SUBJECT: Final draft(s) of MIL-DTL-32139 (see enclosed table for details)

FINAL REPORT

CONNECTORS, ELECTRICAL, RECTANGULAR,
NANOMINIATURE, DUAL ROW, PLUG, RECEPTACLE, POLARIZED SHELL,
PIN, SOCKETS CONTACTS, VERTICAL PCB SURFACE MOUNT SHELL TYPE

PROJECT NUMBER: 5935-2023-054

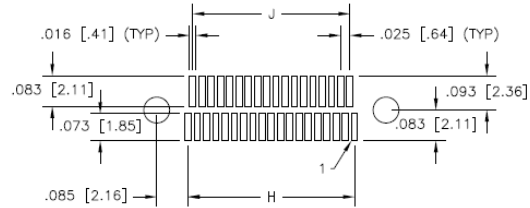
1. Figure 1, D dimensions:
Manufacture A - responded for shorter dimensions.
Manufacture B – keep the larger dimension from the initial draft.
Manufacture C – no comment.
2. Leads for the co-planer – there was difference in tolerance:
Manufacture A - Data indicates tolerances should be leads to be co-planer within .002 above to .004 below mounting surface.
Manufacture B – leads to be co-planar within .004 above to .001 below the mounting surface.
Manufacture C – prefer +/- .003 from co-planar.
3. The recommended PC board pad lengths do not match other manufactures:
Manufacture A – Recommend showing PCB layout for each size and eliminating dims E and F.
Manufacture B – Agreed with mfg. A.
Manufacture C – responded for longer pad dimensions.

1. Figure 1, D dimensions – Manufacture B is proposing to label a MAX dimension which was the larger dimension from the initial draft. Thus, allowing the other manufactures to meet the specifications.
2. Since there were a difference among manufactures, DLA is for a looking for consensus from the manufacture industry on the co-planar tolerances.
3. Manufacture B submitted new tables and drawings. Larger PC pads are included for the size 85. The larger pads should allow for the size 85 contacts. Please see the included drawings below.

Proposal 1: Figure 1, D dimensions.

Glenair (Manufacture A) - Regarding dimension D as a MAX dimension, which is the washout area where the leads exit the shell. Converting dim D to a Max dimension works for Glenair in that our current shell designs and tooling is set for a dimension that is .023 less than a D Max and it is not a critical feature for functionality. Manufactures will have to ensure their washout dimension, while allowed to be less than the D MAX, does not encroach on the PCB pads presenting a shorting possibility.

Ulti-Mate Connector (Manufacture B) - We made this dimension on the table as a MAX dimension so that other competitor dimensions would also be allowed.

Omnetics (Manufacture C) -To clarify, for D dimension, we requested the tolerance on that value to be +/- .010 instead of default .005 since our standard dimension D is .005" smaller than the nominal D dim listed in the table such that we would not expect to exceed the listed dim D +.005 but may have a lower value.

Conclusion - Acceptance of the D MAX with the larger dimensions to meet all manufactures dimensions and tolerance of +/- .010.

RECOMMENDED PC BOARD LAYOUT
FOR SIZE 9 THROUGH 69
(COMPONENT SIDE)

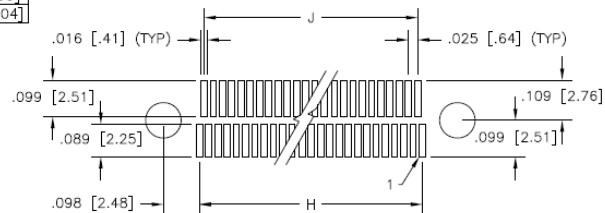
Proposal 3: The recommended PC board pad lengths do not match other manufactures.

Glenair (Manufacture A) - The key word is “recommended”. The PCB layout is not a part of the M32139/15 or /16 product. The layout is a guideline for customers to develop their PCB’s using these connectors. Therefore, the proposed layout does not affect the Glenair product. Glenair made changes to their recommended PCB layouts for vertical surface mount connectors around the 2015 time frame after assessing the ability to get a complete heel and toe fillet. The Glenair PCB layouts provide room on the heel and toe to achieve a complete solder fillet and be more forgiving with connector placement.

Omnetics (Manufacture C) - The proposed dimensions are nominally only .011 larger than tails ($.093+.083=.176$ versus $.125+.02+.02 = .165$, respectively). We'd expect our connector to work on the smaller pads and realize toe overhang is permissible per J-

STD-001, but our rationale for larger pads is to minimize risk of toe overhang based on connector, PCB and placement tolerances.

Conclusion – The included initial proposed drawings above will be the acceptable standard SMT pads. The lengths meet all manufactures recommendations.
